Cable Qualification for 5G and 2.5G: Fine Adjustments

Hossein Sedarat (Aquantia)
George Zimmerman (CME Consulting)
Amrik Bains (Cisco)

March 2016

Solution – changes to the draft

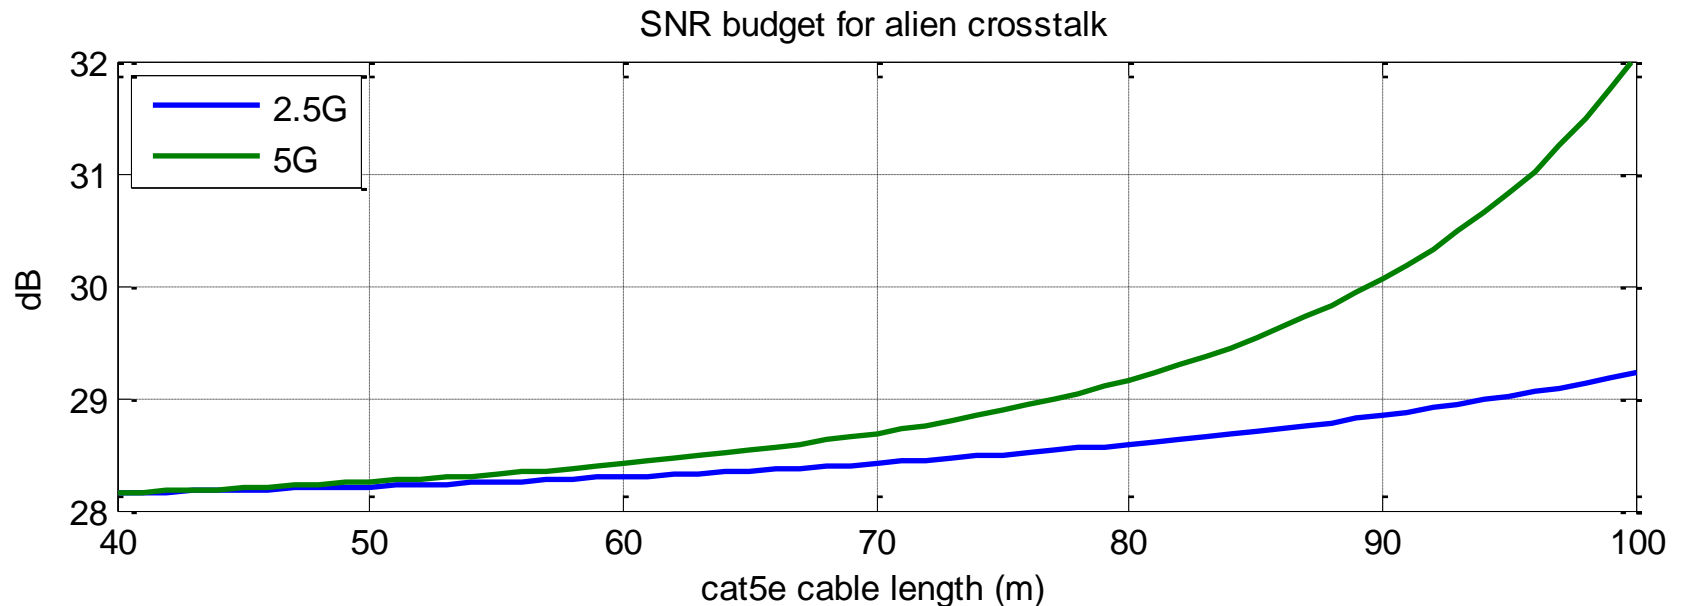
1. In the expression for PSD of noise, include an additive constant PSD term to account for all other sources of impairment
 - 5G: **-135 dBm/Hz**
 - 2.5G: **-129 dBm/Hz**

$$N(f) = 10 \log_{10} \left(\mathbf{10^{other_noise_sources/10}} + \sum (10^{ANEXT/10} + 10^{AFEXT/10}) \right)$$

2. Lower the overall target SNR from 32 dB to **28 dB** to account for the new additive noise term
